Re: Report  
Slope Stability Reconnaissance  
Lots 7, 8, 9, 10, and 11  
Eastwood Subdivision No. 8  
Uintah, Weber County, Utah  
For Ms. Janet B. Bean

Re: Report - Addendum  
Slope Stability Reconnaissance  
Lots 7, 8, 9, 10, and 11  
Eastwood Subdivision No. 8  
Uintah, Weber County, Utah  
For Ms. Janet B. Bean

| Project:<br>Review of a slope-stability report for lots in the Eastwood Subdivision No. 8, Uintah, Weber County, Utah. |                  |                         | Requesting Agency:<br>Weber County Planning Commission |

7-2-92 UGS REVIEW  
INTRODUCTION

Figure 2  
Location Map

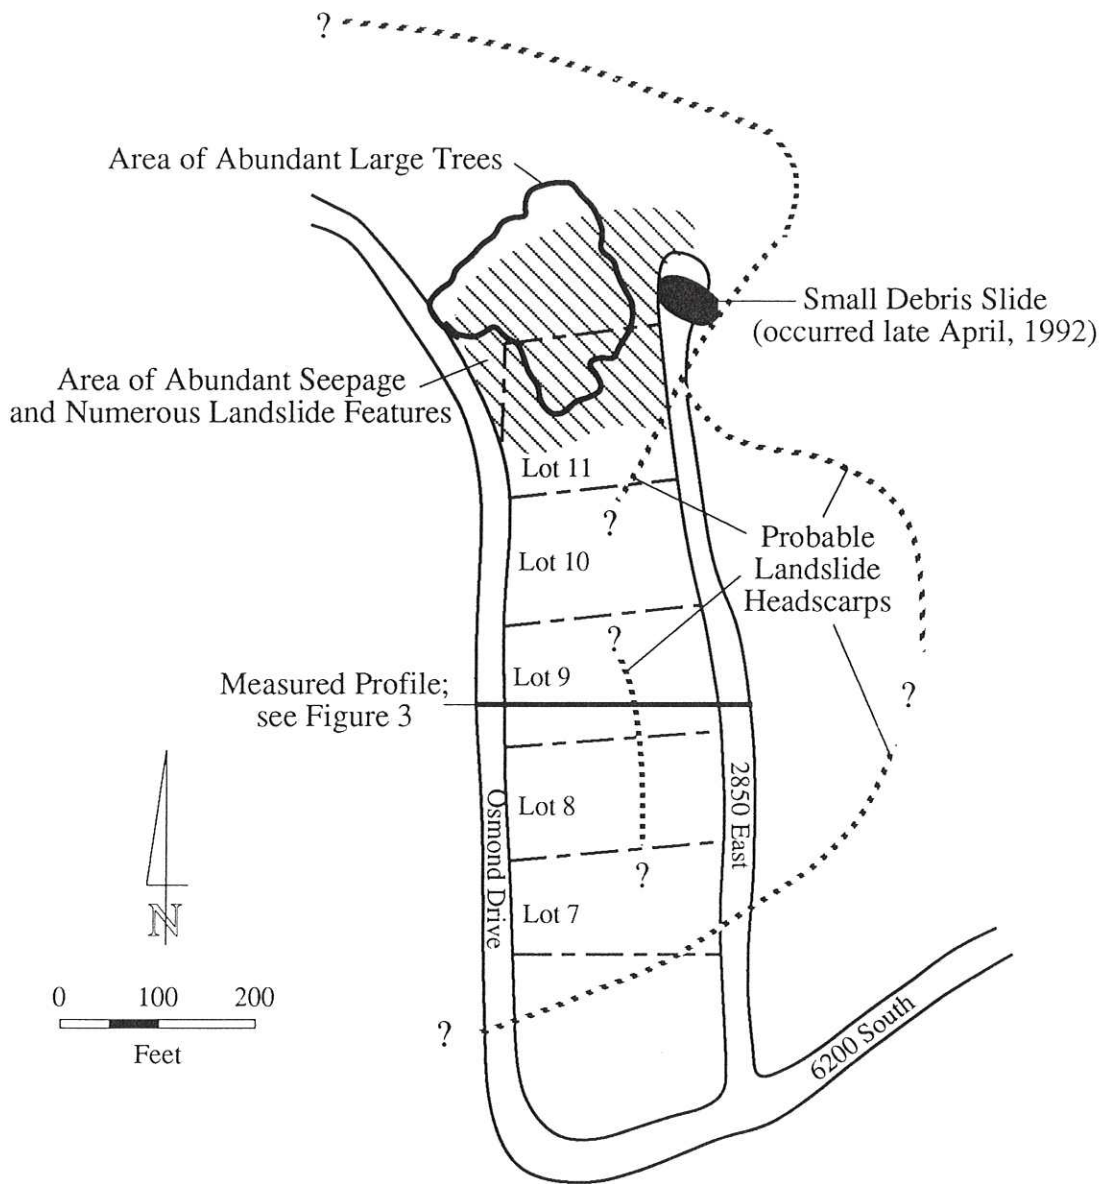
Lowe (1988a) mapped an active landslide in the northern part of the subdivision that impacts lot 11 and possibly lot 10. This area is shown on SH&B figure 2 as an "area of abundant seepage and numerous landslide features." Because of the presence of a possible active landslide in this area, I concur with the statement in the report (p. 3) that development on lot 10 would require further site-specific study, and that lot 11 may require extensive remedial treatment that may be economically unfeasible.

Figure 3  
 Profile Across Southern Part of Lot 9,  
 Eastwood Subdivision No. 8,  
 Uintah, Weber County, Utah

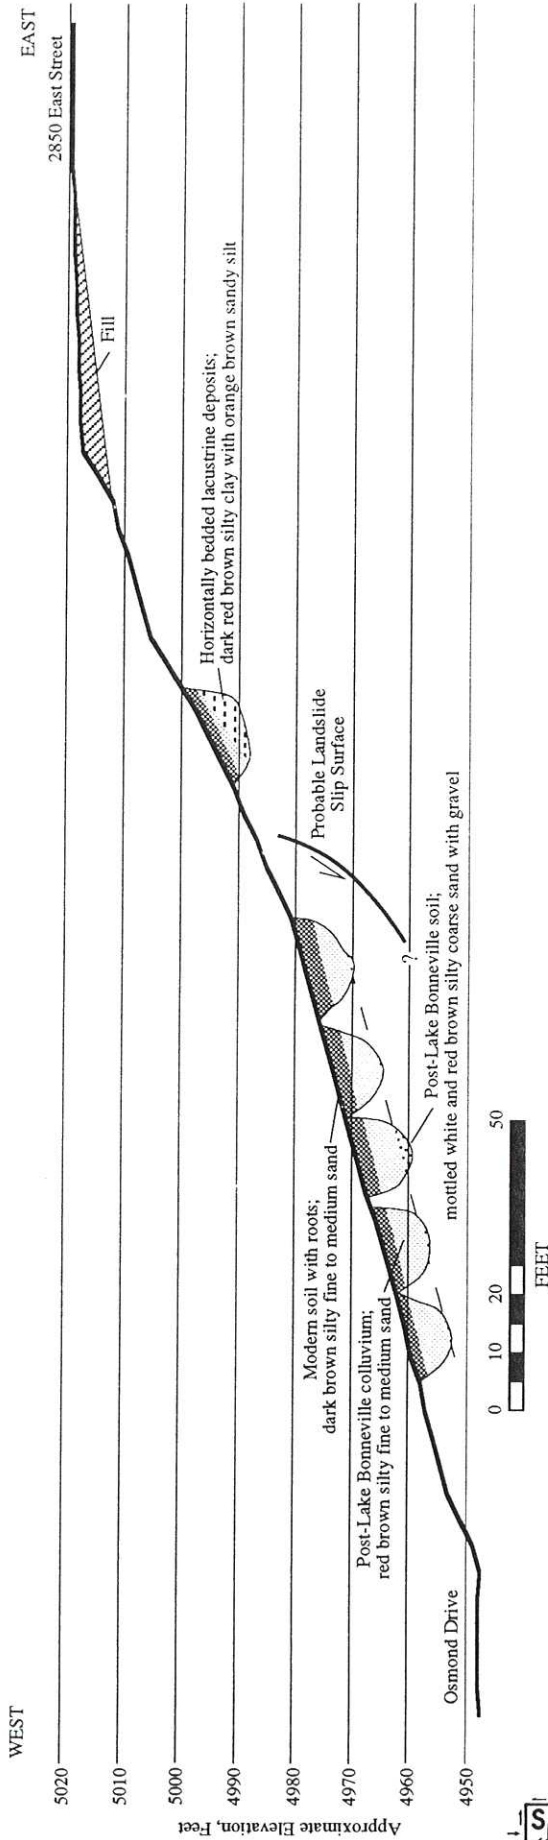
Of particular importance to the issue of past landslide stability at the site is the orientation of layering in the subsurface materials. From a depth of about 10 feet to 26.5 feet, the layering was consistently horizontal or nearly horizontal. Above 10 feet and below 26.5 feet, the soils were massive, and layering was not observable. The horizontal nature of the layering found in the boring matches the horizontal layering observed in the upper-most test pit shown on Figure 3 in our May 19, 1992, report.
